35/15-03N **REVISED** 15 West Lenox

Chevy Chase Historic District *pool + balcony*

Staff item

**Jundanian Residence**  
 15 West Lenoir Street  
 Chevy Chase, MD

*New site plan*

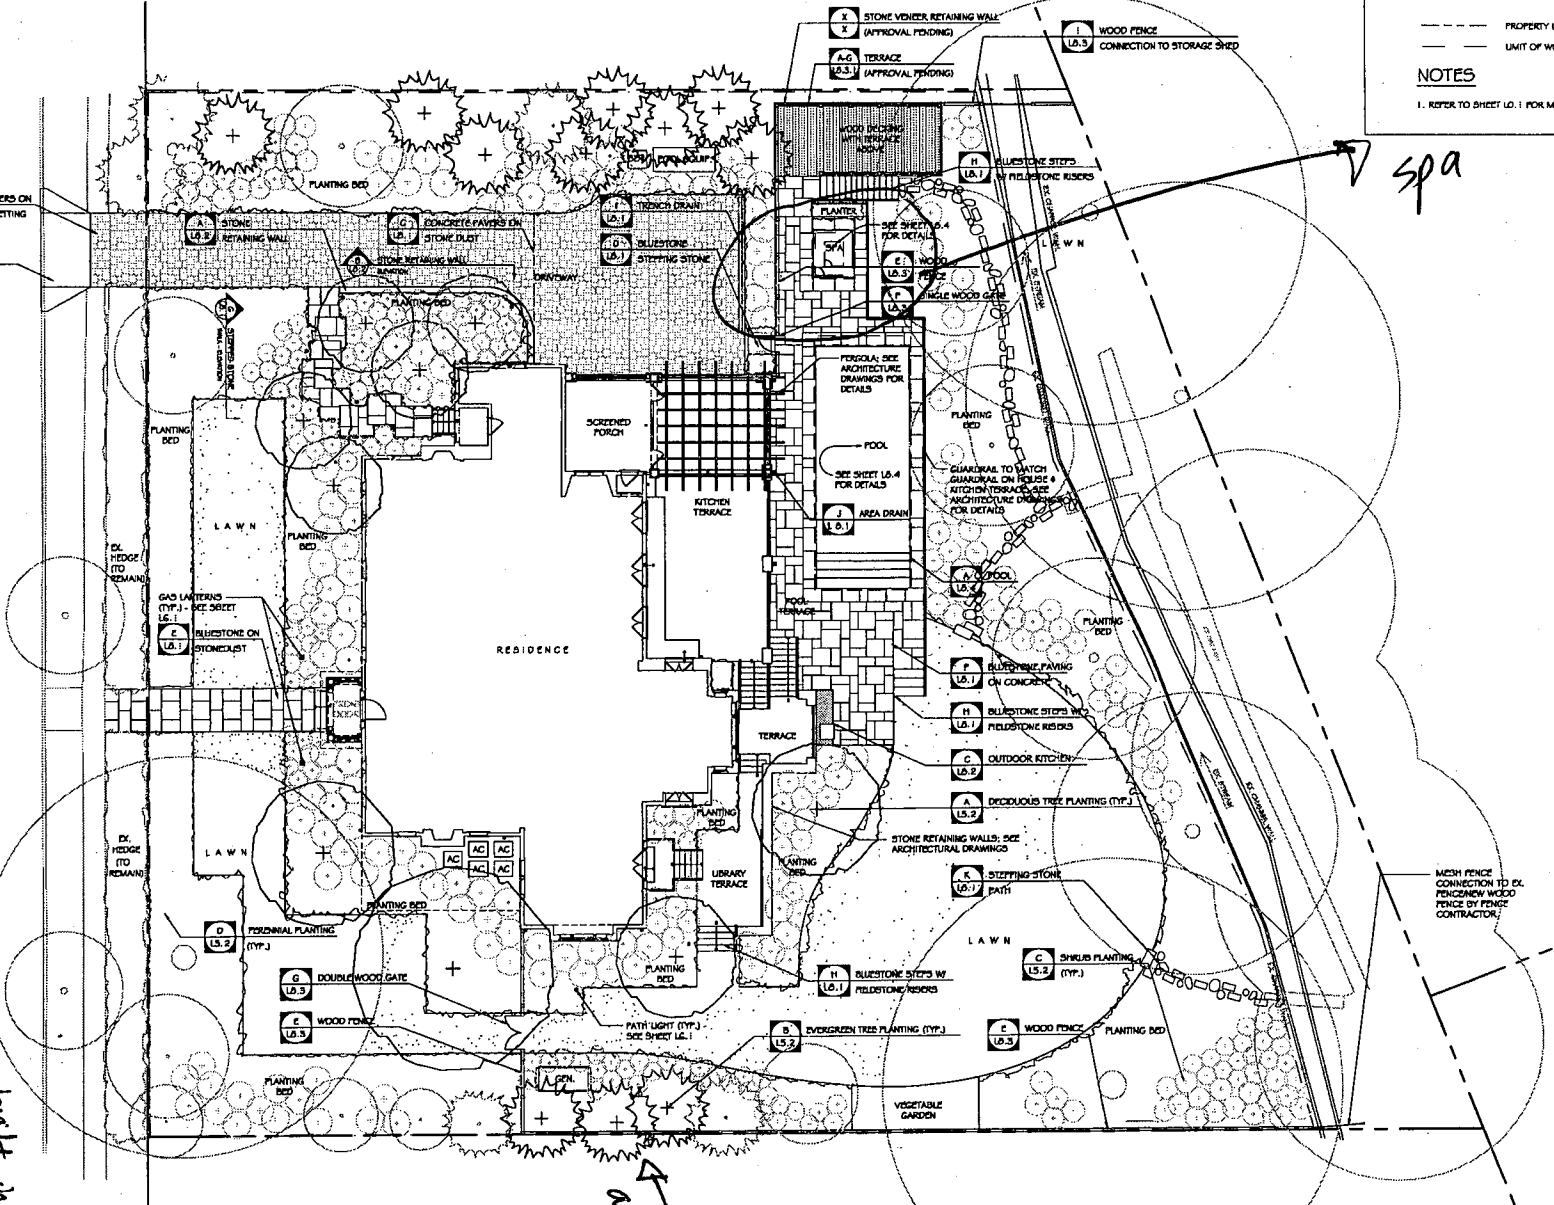
15 West Lenox was approved in May 2005 for a pool and other landscape alterations (patios, fencing, walls, etc.). They submitted the site plan for final approval and stamping and it now shows all the HPC- approved changes plus a spa near the pool.

Does this change require a HAWP revision?

*spa*

*built-in grill on terrace*

*← fencing also along E. side*

I received the 3 site plans but I will need the extra sheets that show the other details (fencing, walls, arbor, etc.) so I can review them and make sure they are what the HPC approved and then stamp them. At this time I cannot stamp the site plan approved since it now shows a spa which was not on the plans that the HPC approved. Please email me the new site plan before 12:30pm Wednesday so I can take it to the HPC meeting tomorrow night (we cannot reduce full size plans for copying). I will show it to the HPC and ask them if this change requires a revision and will let you know Thursday, but I believe they will require a revision. Was the new site plan showing the spa submitted to the Village?

Sheet #  <b>D-3</b>	Title <b>Driveway Plan</b>	
	Date 11.28.05	Scale 1" = 20'-0"

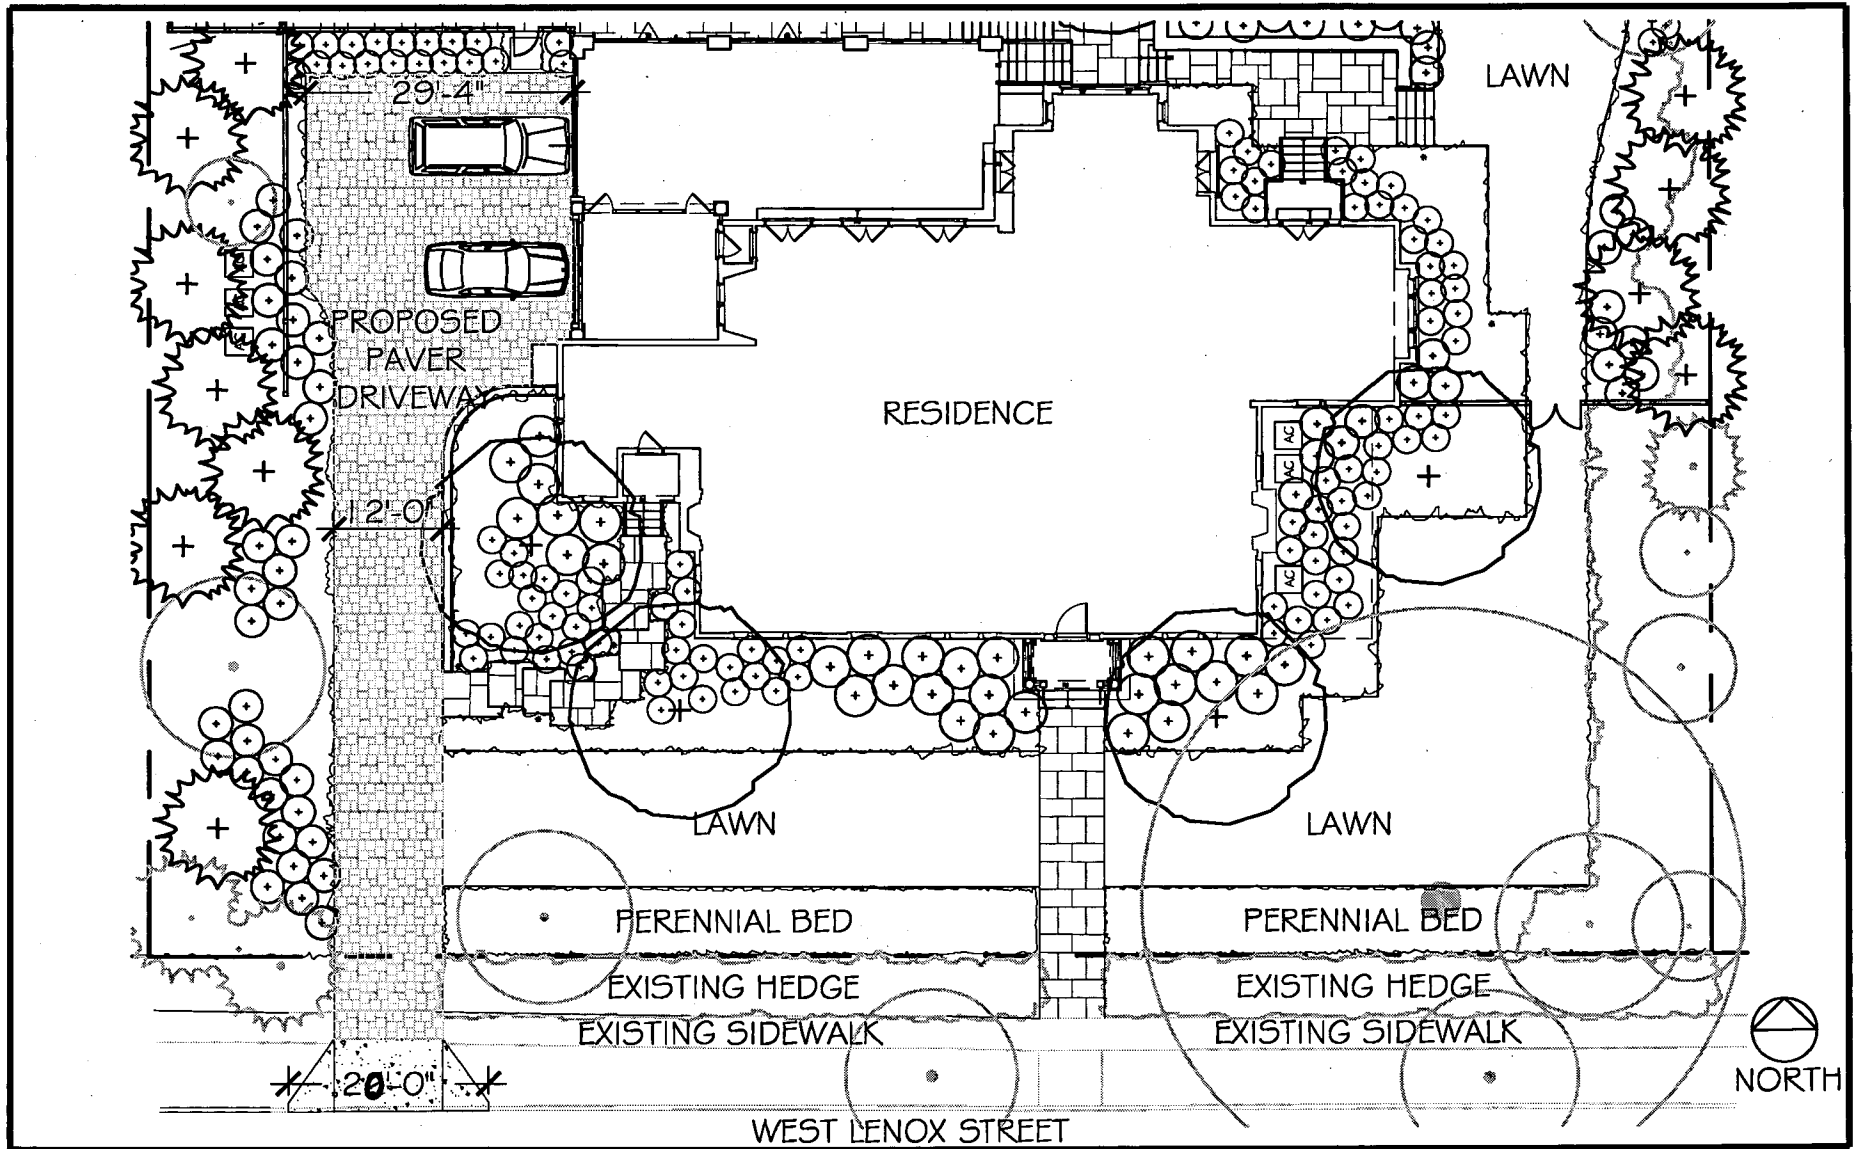
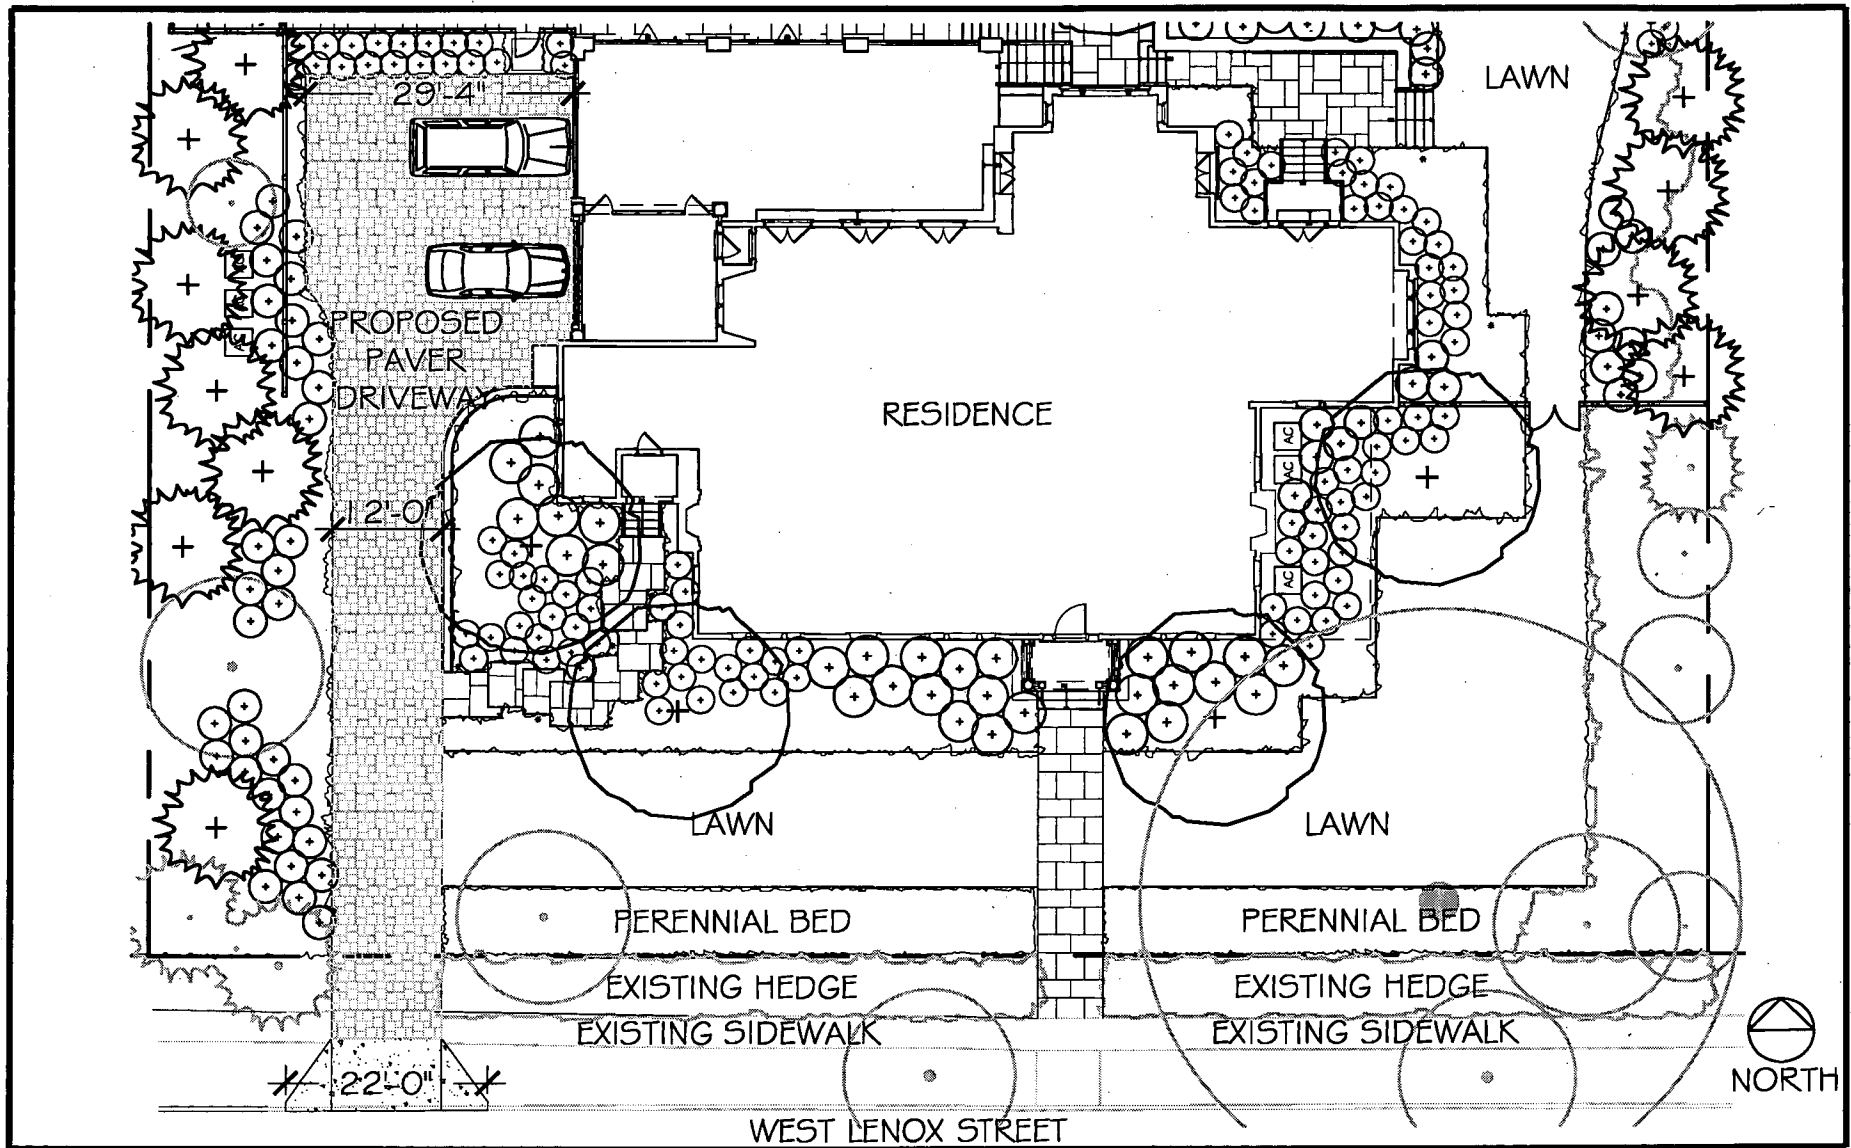
The applicants are requesting staff level approval to change the driveway material from the existing asphalt to concrete or stone pavers. The driveway configuration has already been approved by the HPC in the previous site plan, so only the material change is being requested. Chevy Chase Village has reviewed and approved the proposed changes. Driveway plan showing the proposed pavers is attached.

I've attached a PDF with the proposed Driveway and the letter from Chevy Chase for the proposed driveway renovations at 15 West Lenox Street. Please note that we are going to change the curb cut from 22'-0" as proposed to 20'-0" as directed by the Village. Happy Holidays! Thanks.

Last night at the worksession the HPC approved the proposed change in driveway material from asphalt to pavers at 15 West Lenox. The driveway site plan had been previously reviewed and approved as part of the landscape plan in the Historic Area Work Permit.

Pursuant to the plans submitted for the record, however, the driveway apron may be expanded to a total maximum width of twenty-nine feet, four-inches (29'-4") in front of the two-car garage and the driveway may be expanded to a maximum width of twelve-feet (12') in the public right-of-way.
